**AGENDA
CITY OF CEDAR FALLS, IOWA
PLANNING AND ZONING COMMISSION
WEDNESDAY, OCTOBER 24, 2018
5:30 PM AT CITY HALL - COUNCIL CHAMBERS**

TO: Planning and Zoning Commission
FROM: Iris Lehmann, Planner I
DATE: October 18, 2018
SUBJECT: Design review of a property in the Central Business District Overlay

TO: Planning and Zoning Commission
FROM: David Sturch, Planner III
DATE: October 18, 2018
SUBJECT: Highway 1 District Site Plan Review – Raising Cane’s Sign Amendment

TO: Planning & Zoning Commission
FROM: Shane Graham, Planner II
Updates and recommendations provided by Karen Howard, Planning & Community Services Manager
DATE: October 18, 2018
SUBJECT: Fleet Farm Retail and Convenience Store Site Plan Review

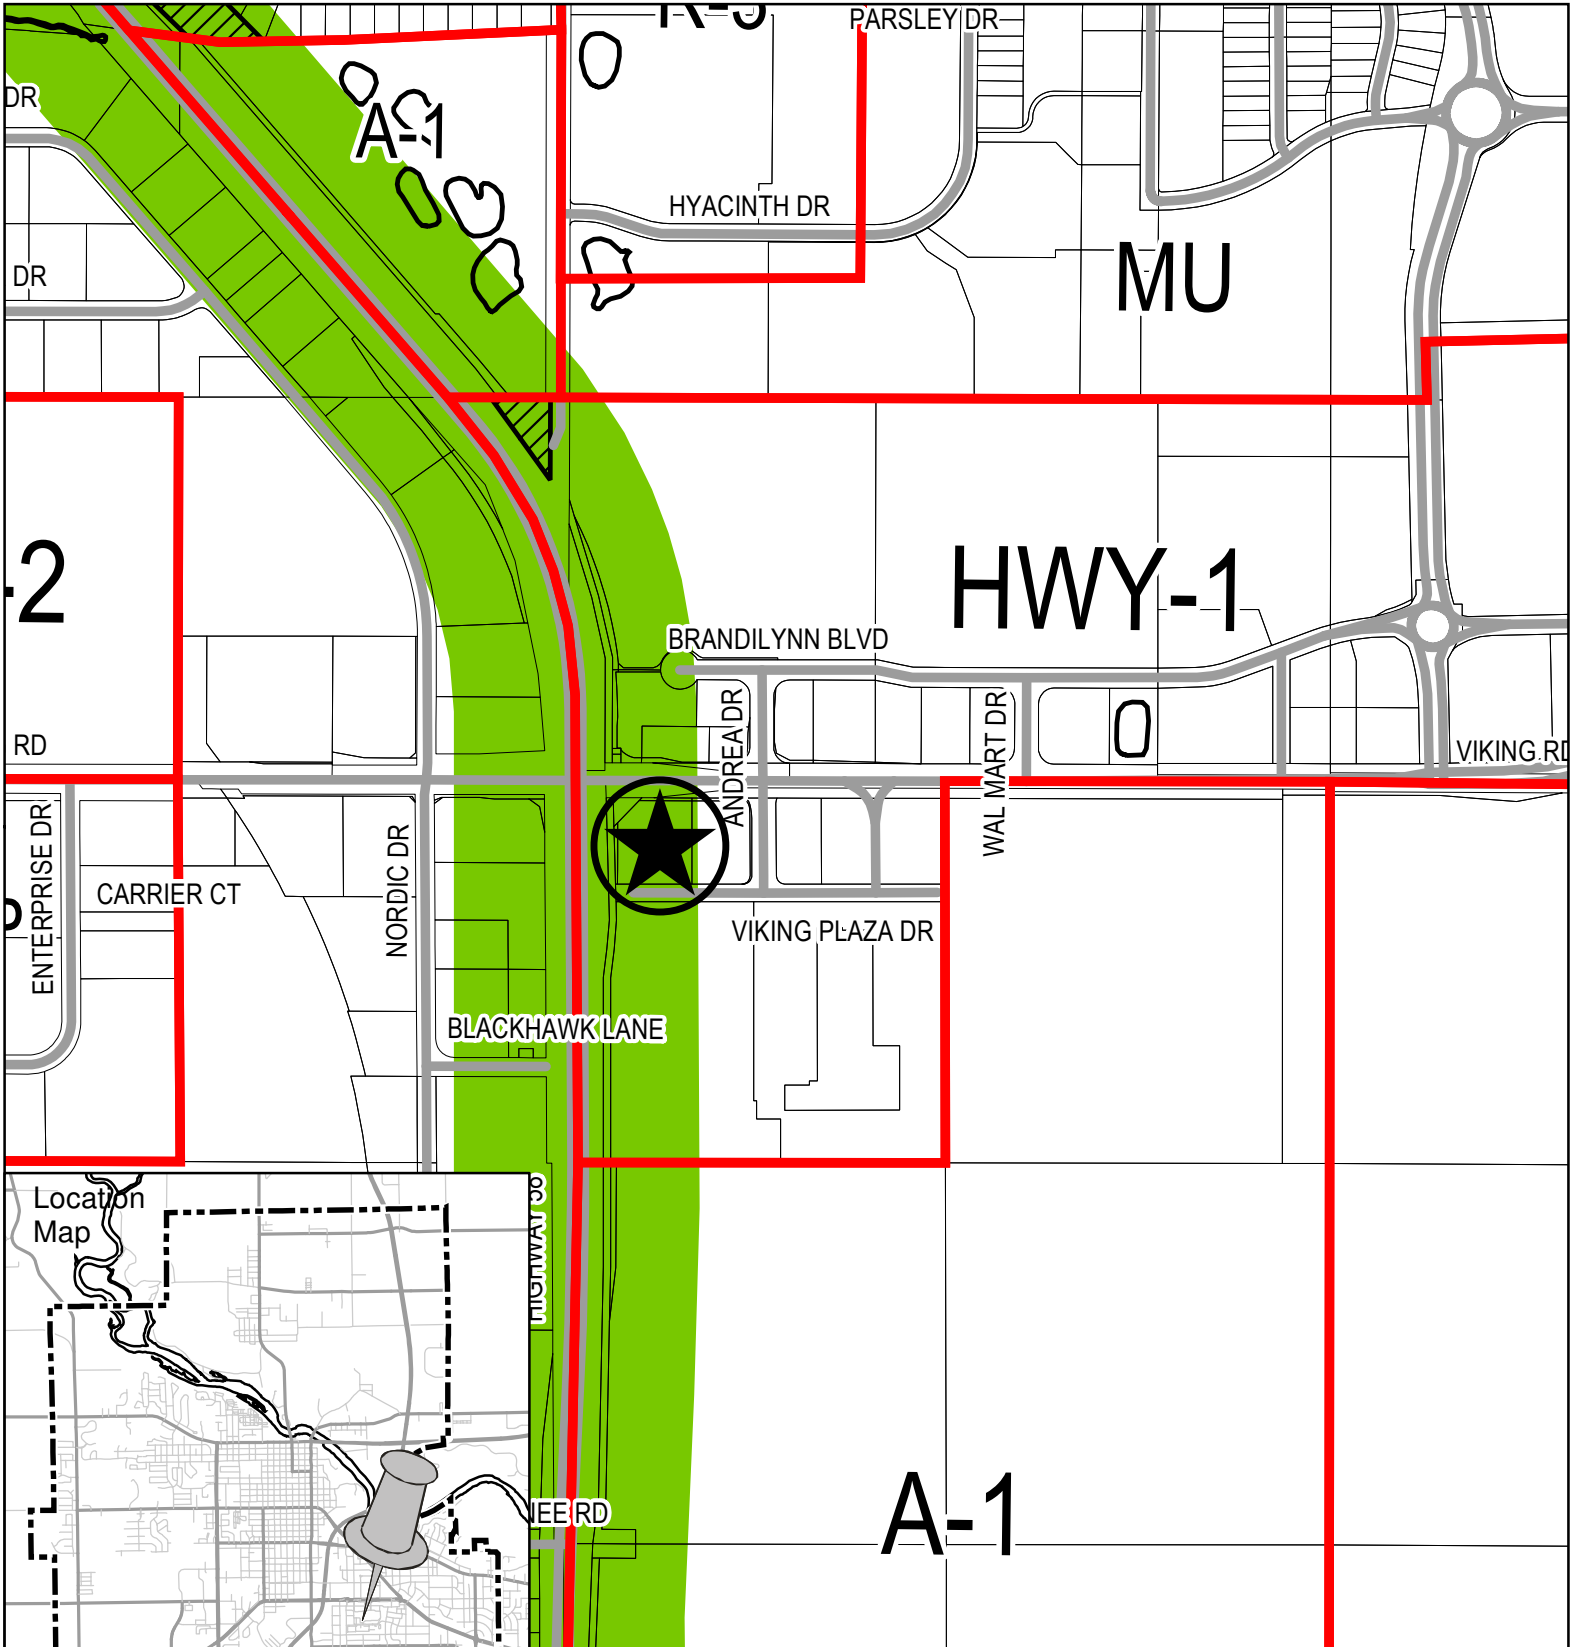
The architect indicated that they wish to amend their signage plan to include a monument sign for the restaurant. The proposed sign will be 6 feet in height and 22 square feet in area placed upon a 2 foot tall brick base. The monument sign will be supported by steel beams on both ends of the sign. These steel beams tie into the design of the building. The drawing below identifies steel awnings and sun shades over the windows and outdoor seating area for the proposed restaurant. **Amended signage plan satisfied.**

- 2) **Setbacks:** The setbacks apply to the building, parking lot and signage. The HWY-1 District requires a 20-foot setback around the perimeter of the "district" and 20 feet along the public streets. The 20-foot setback applies to the north, south and west side of the property. There are no internal setbacks along the east lot line. The site plan depicts the proposed monument off the northeast corner of the parking lot with a 20-foot setback along Viking Road. **Setbacks satisfied.**

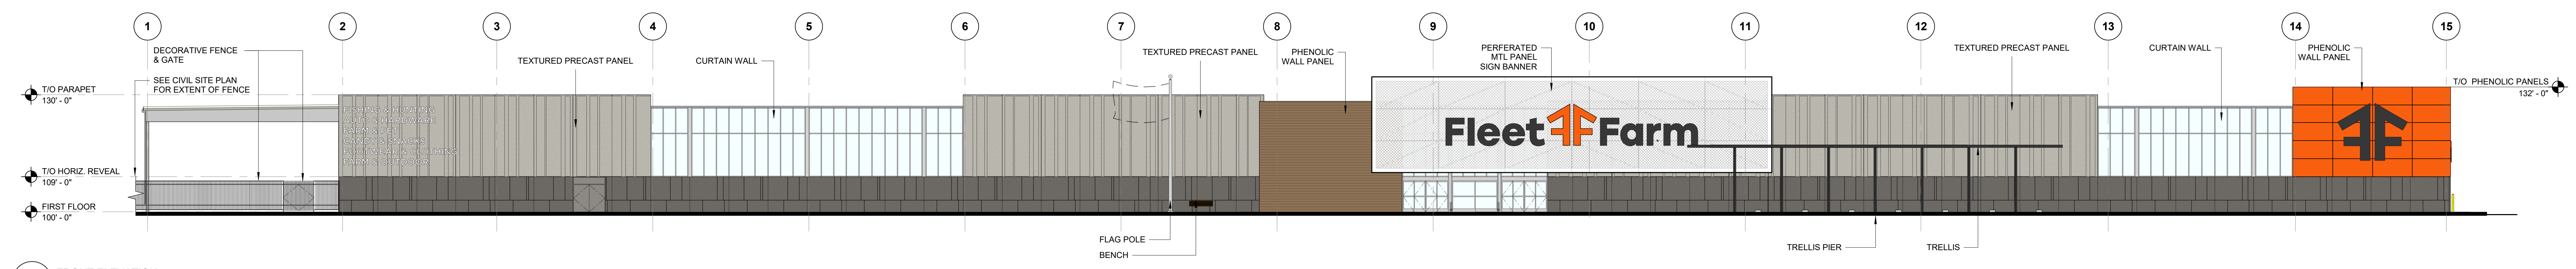
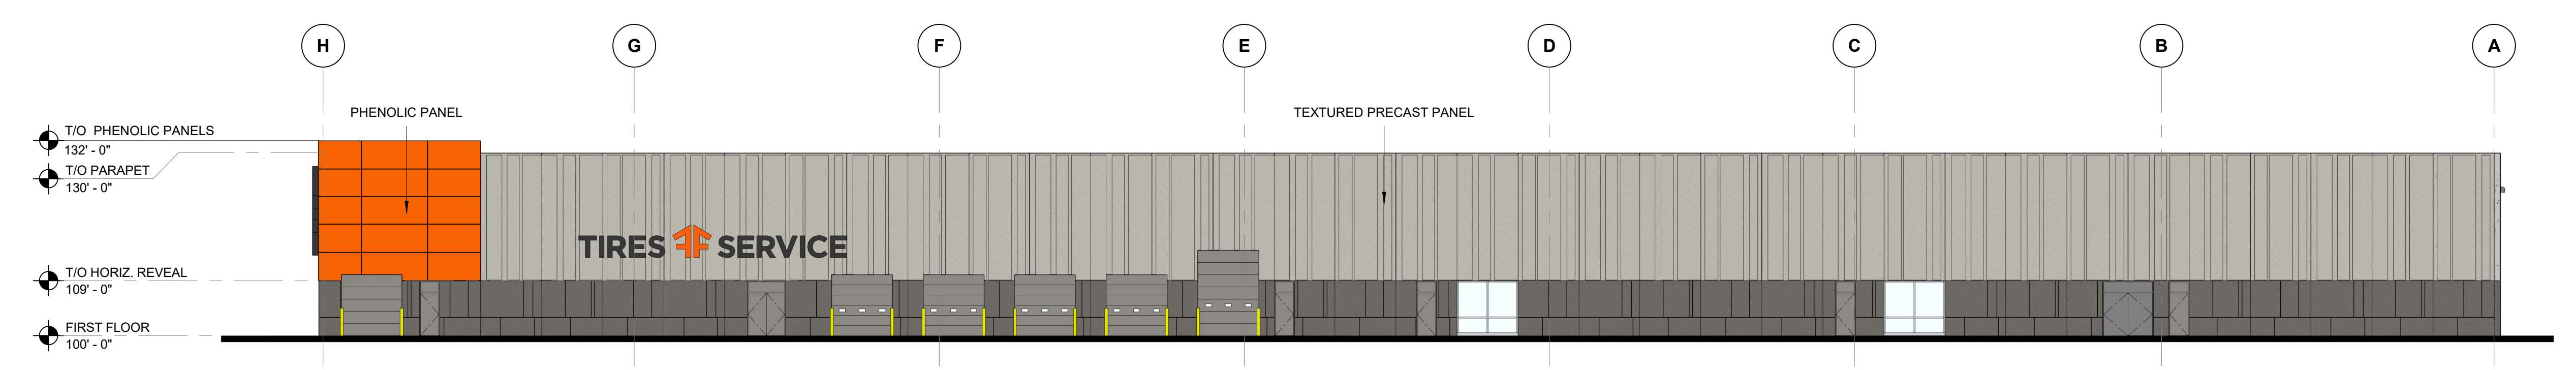
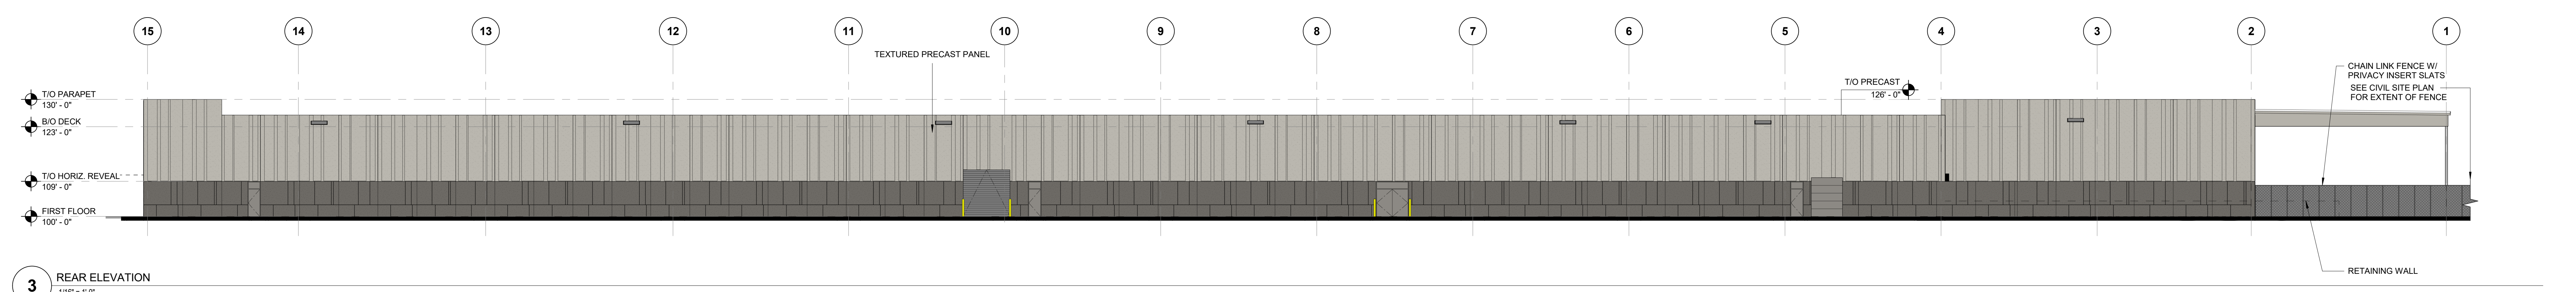
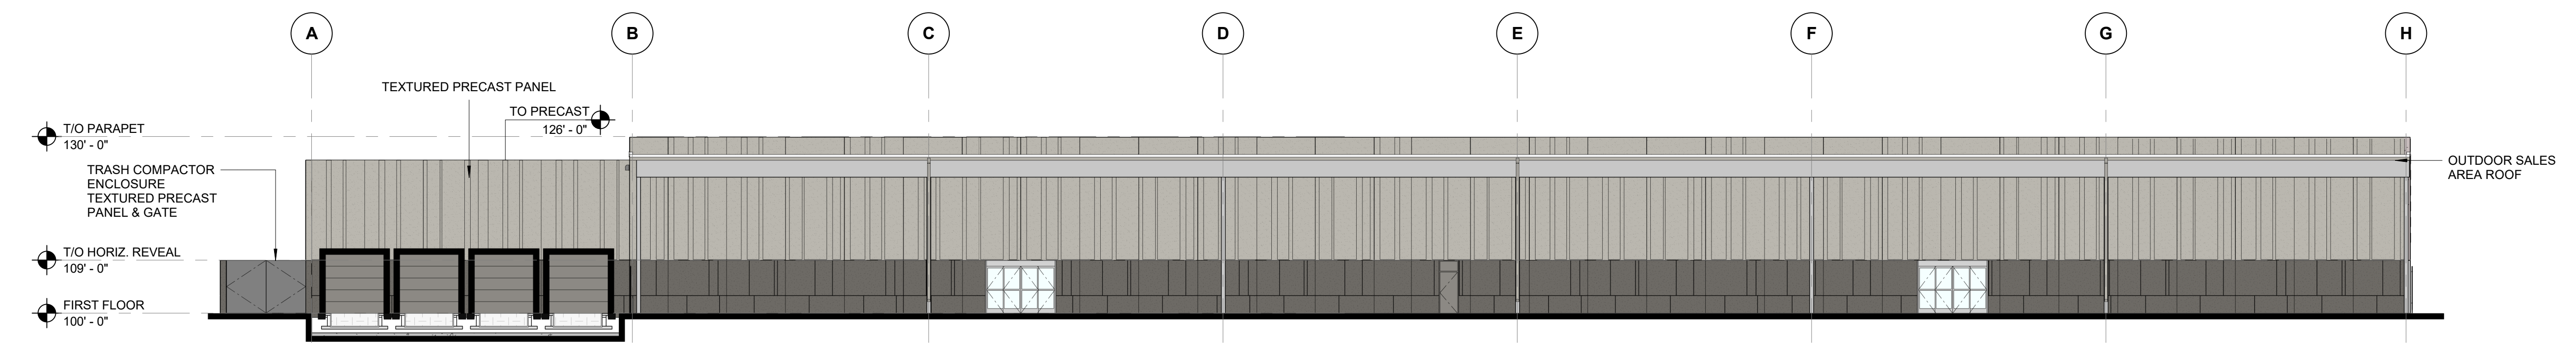
Mr. Holst asked about the design of the side of the convenience store that faces Ridgeway and noted that it appears to be a rather blank facade. Jennifer Buck with RSB Architects stated that they would look at the design and would add some additional features to create

more visual interest and some articulation to the façade that will tie into the main store to add depth and character to that side.

Mr. Holst reiterated his concern with the design of the site as an entranceway to the City and would like to see an enhanced design for the convenience store. Ms. Saul stated that she likes the additional landscaping that has been added. Mr. Hartley asked if the gas station will be geared toward automobiles or if it will be a truck stop. The developer responded that it will not be a truck stop.
